ADDENDUM 1 – JOB 39

TO: All prospective bidders on project SOIB-CPU-7-023(050)910, Job No. 39 scheduled for the November 17, 2017 bid opening.

**ADDENDUM 1
JOB NO. 39**

TO: All prospective bidders and suppliers on Project SOIB-CPU-7-023(050)910, Job No. 39 in McKenzie County, scheduled for the November 17, 2017 bid opening.

STATE	PROJECT NO.	SECTION NO.	SHEET NO.
ND	SS-7-023(050)910	11	17

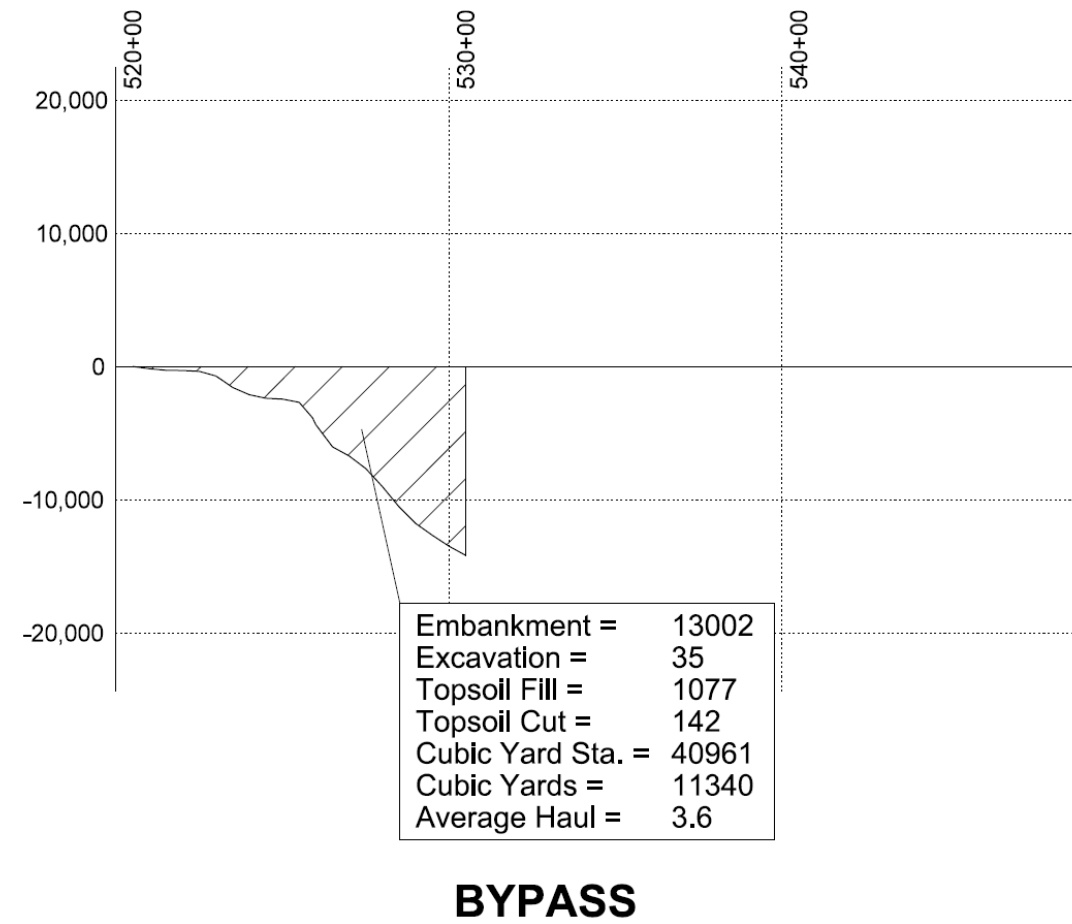
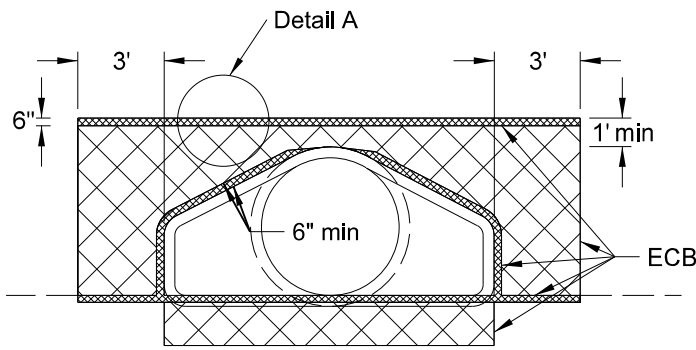
- Section 11, Sheet 9: The earthwork quantities for the Temporary Bypass were updated in the summary table for Option 2.
- Section 11, Sheet 17: The Temporary Bypass end area values and mass haul diagram were updated.

STATE	PROJECT NO.	SECTION NO.	SHEET NO.
ND	SS-7-023(050)910	60	1

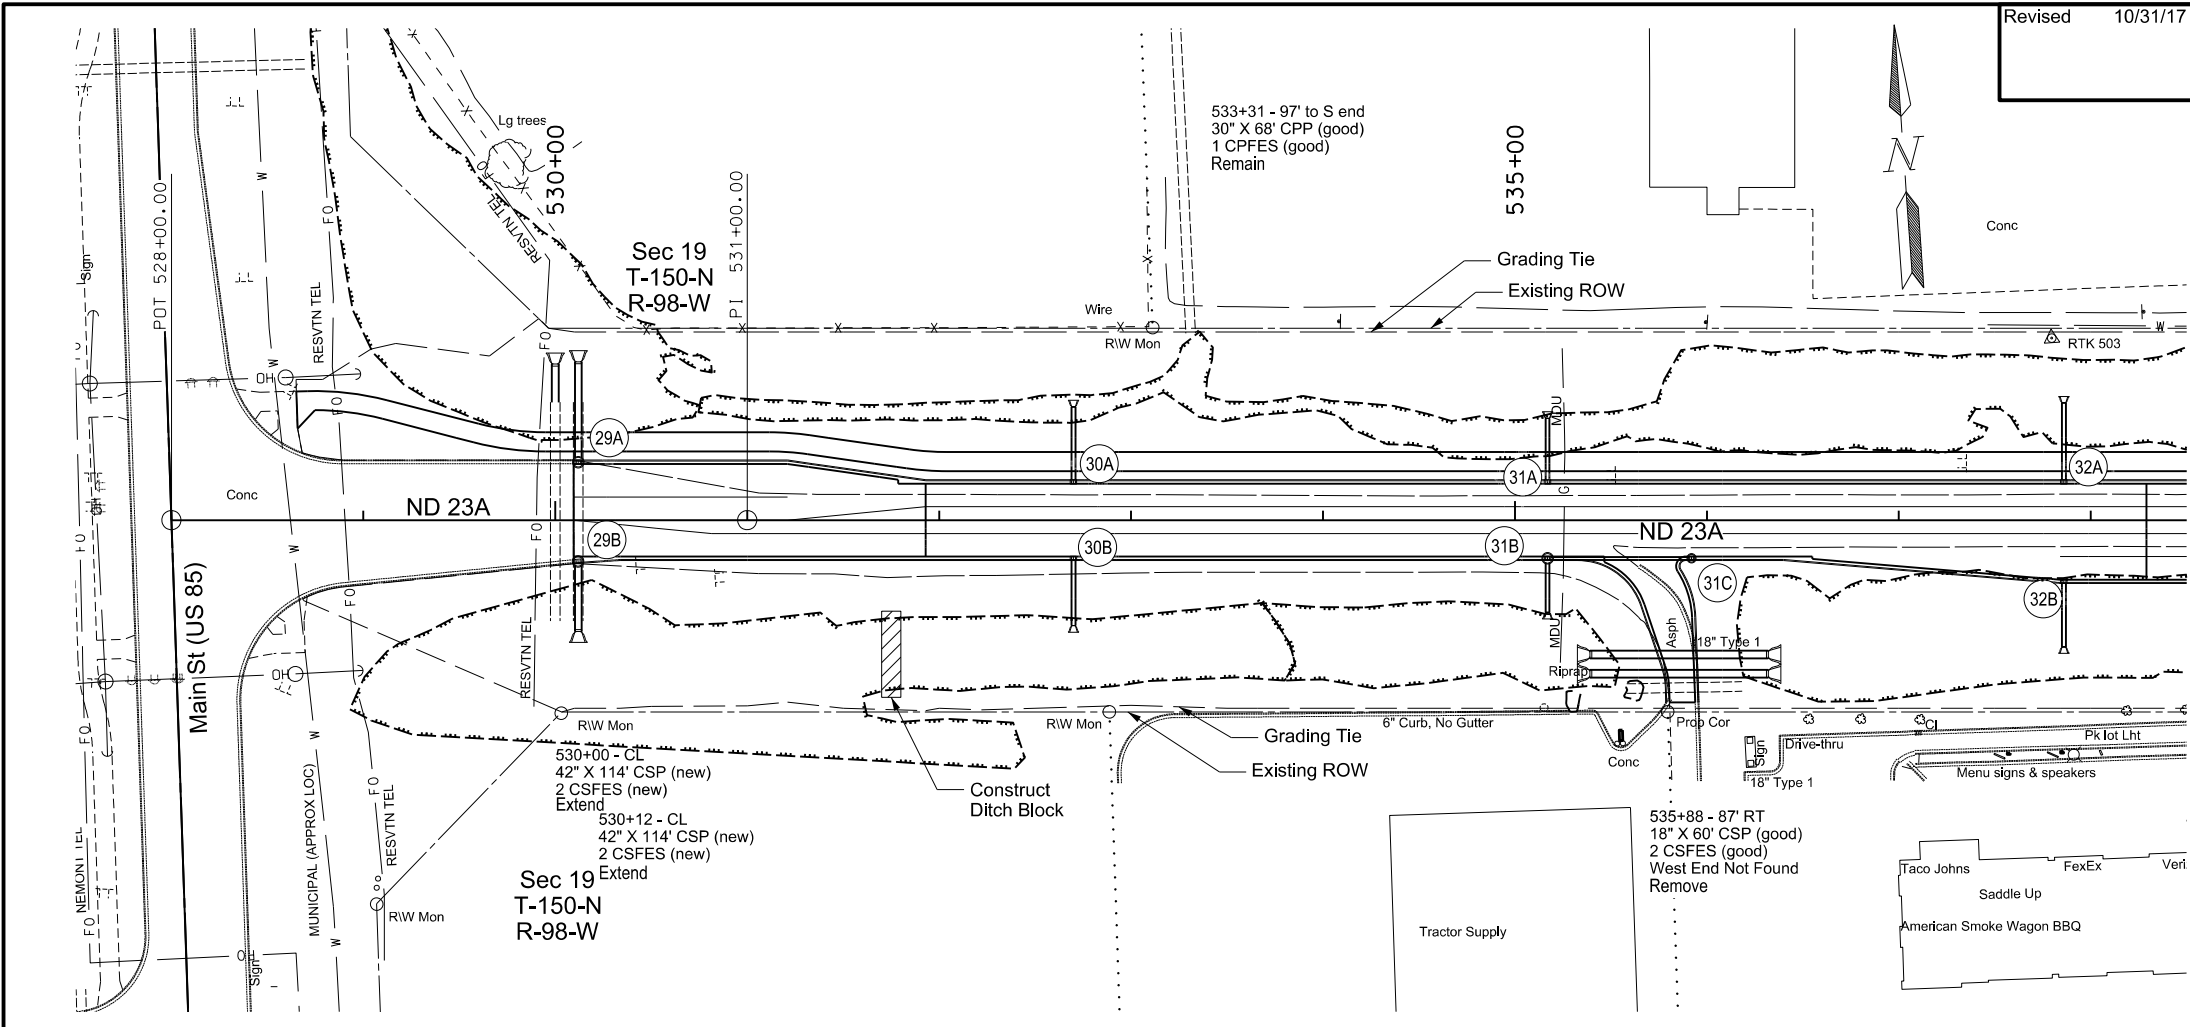
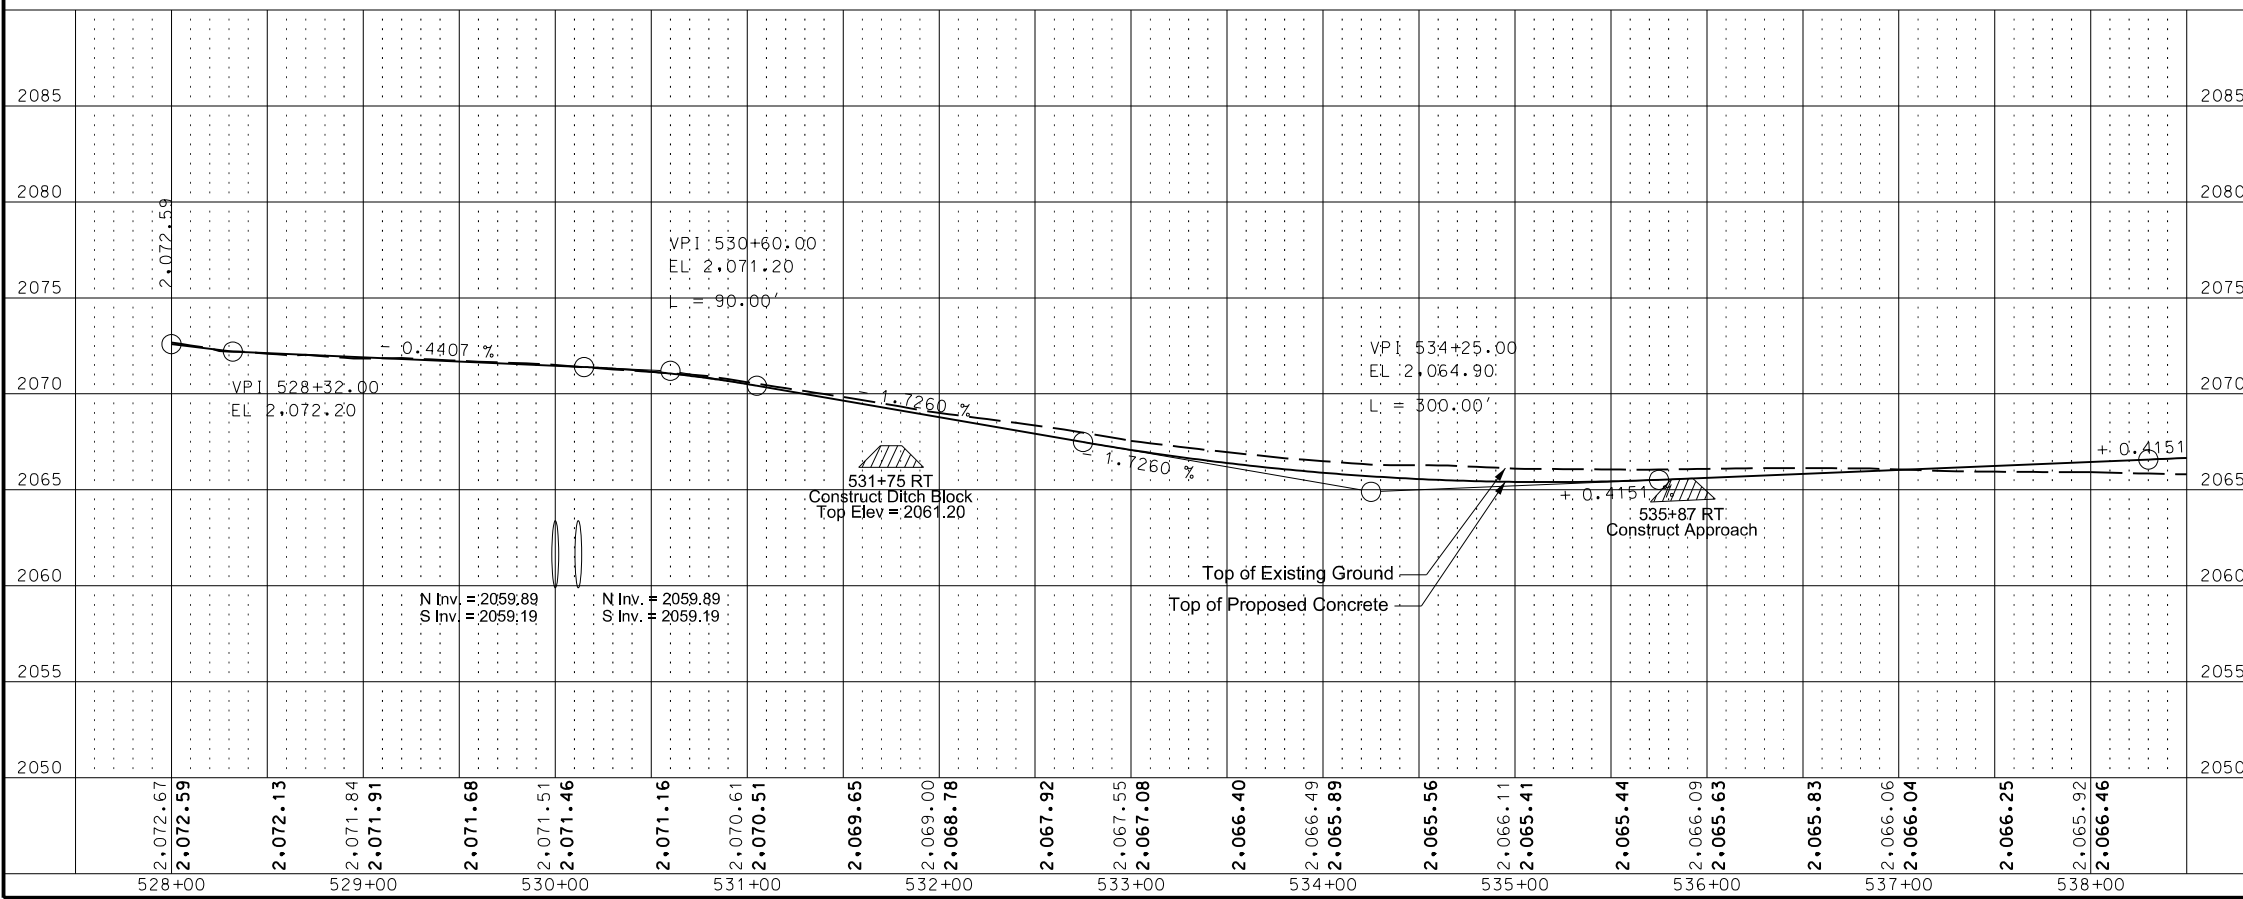
- Section 51, Sheet 1-5: The allowable pipe list was updated.
- Section 60, Sheet 1: The pipe conduit bid items were changed.
- Section 60, Sheet 2: The pipe conduit bid items were changed.

STATE	PROJECT NO.	SECTION NO.	SHEET NO.
ND	SS-7-023(050)910	60	6

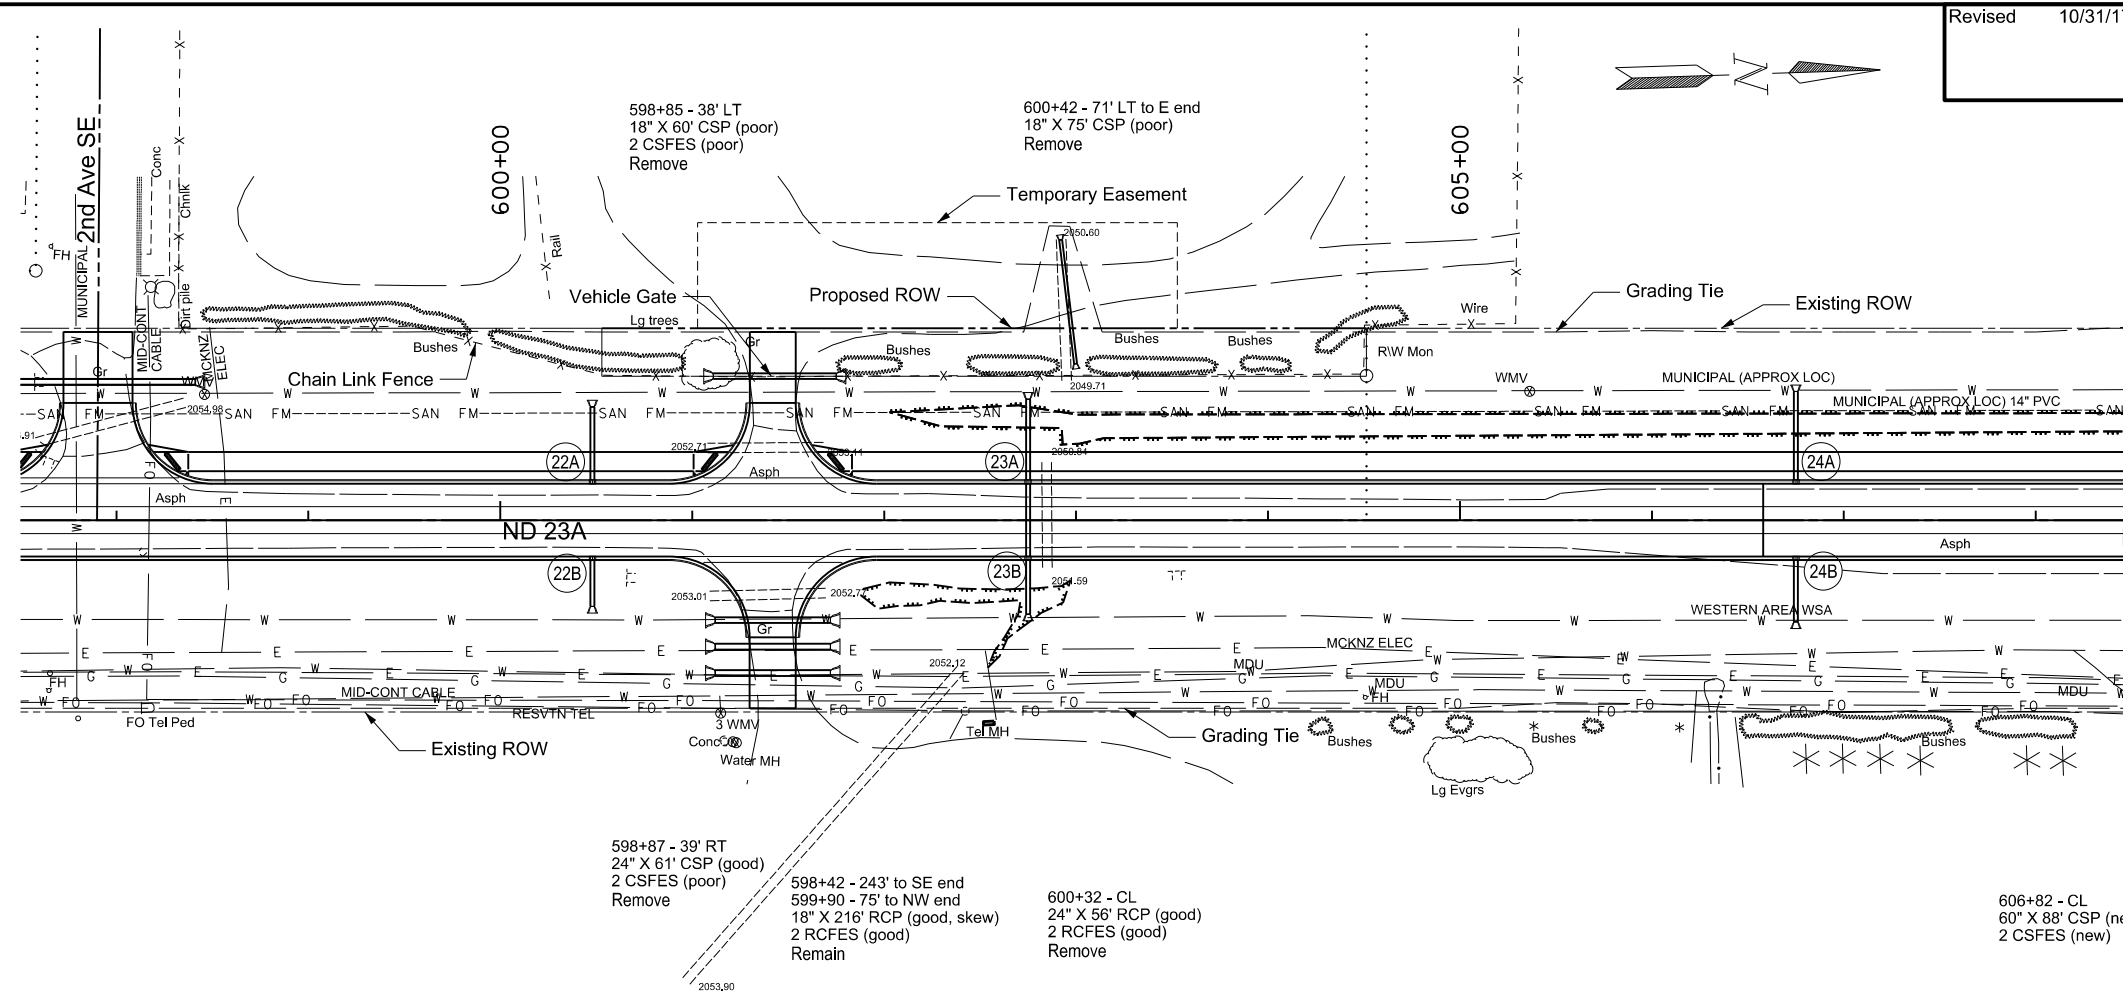
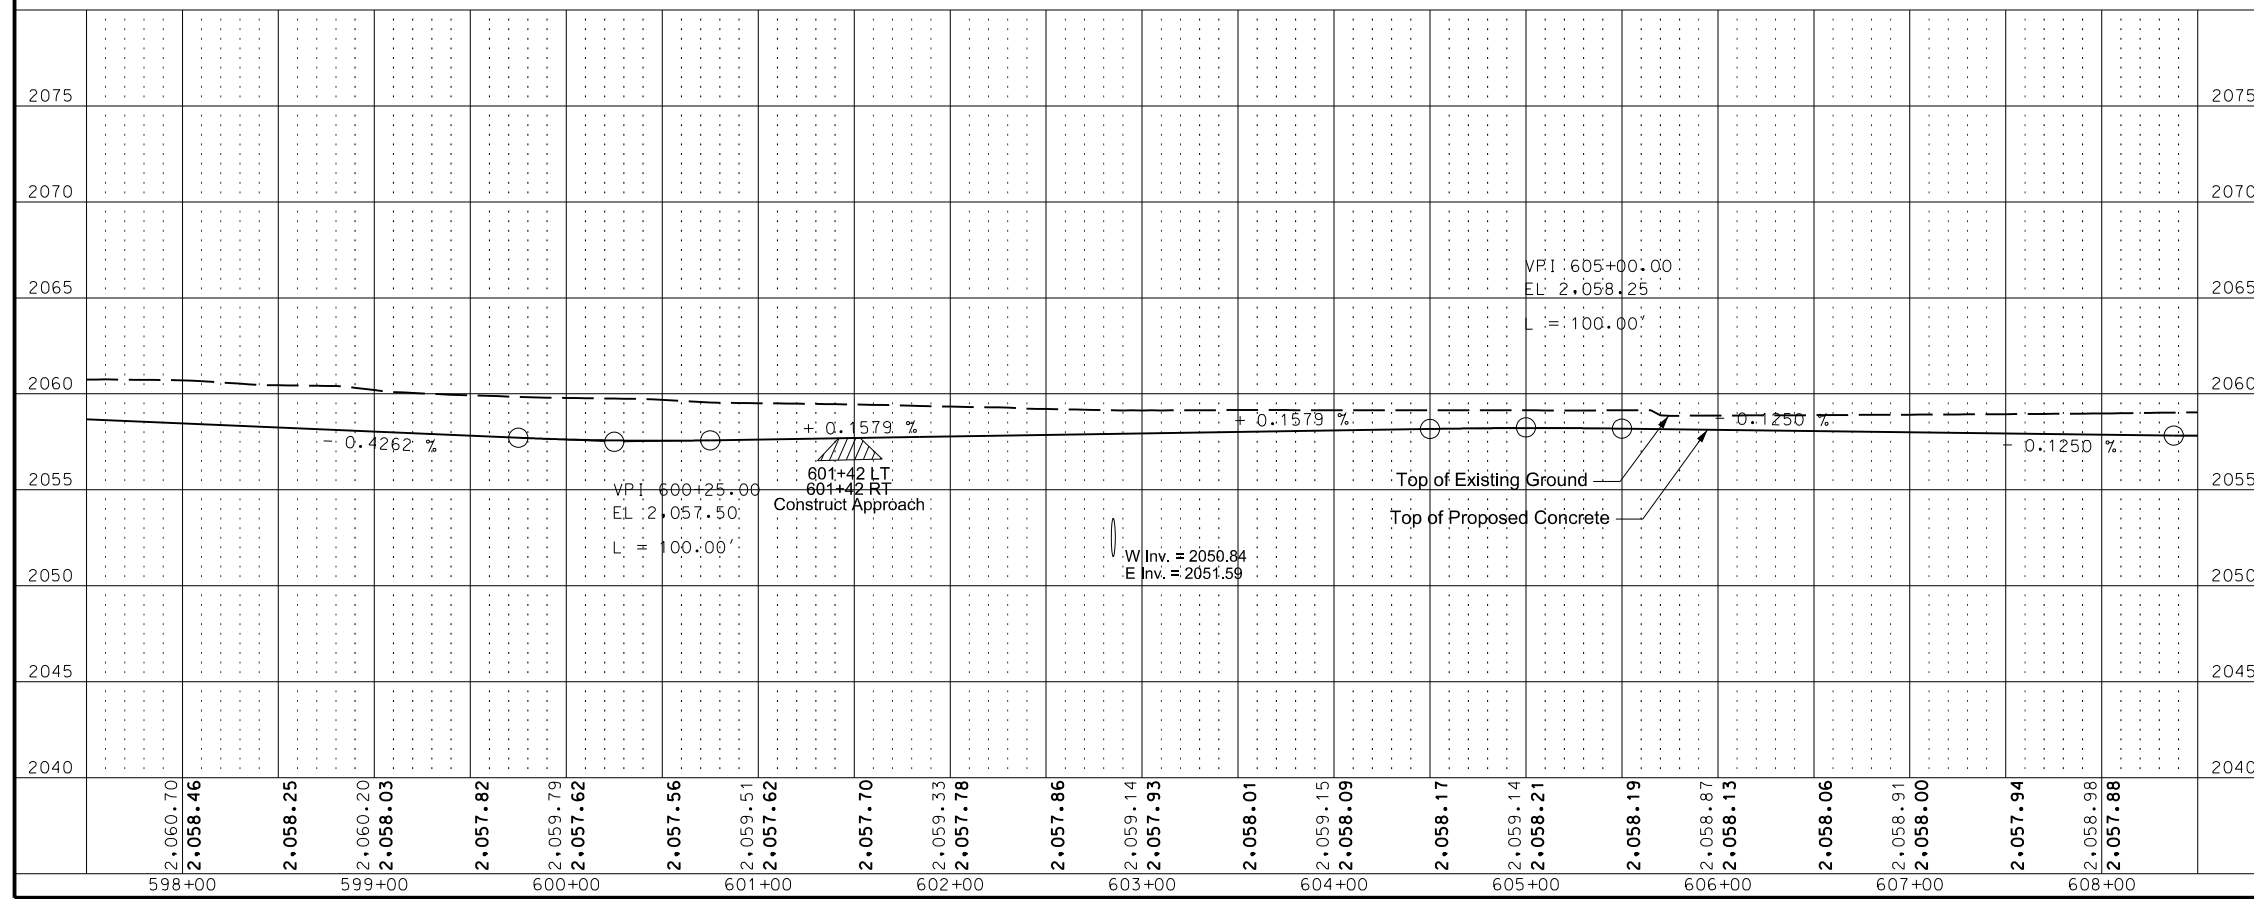
- Section 60, Sheet 4: The pipe conduit bid items were changed.
- Section 60, Sheet 6: The Pipe Conduit Arch 58IN x 36IN Approach bid item was changed to Pipe Conduit 36IN Approach.
